STARTING DEVICE – NEW TERMINAL BLOCK

New starting device /motor protection for appliances with compressor MH1050Y. The terminal block SX.J7 replaces starting devices SX1J7 and SS1J7.

Starting device SS1J7

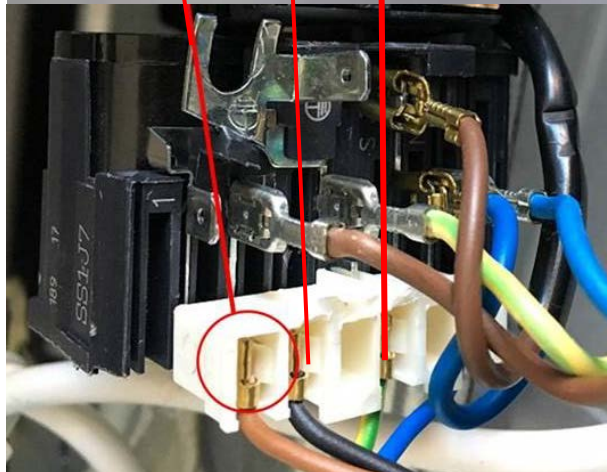
Move the white connector block on the starting device SS1J7 to the new terminal block.
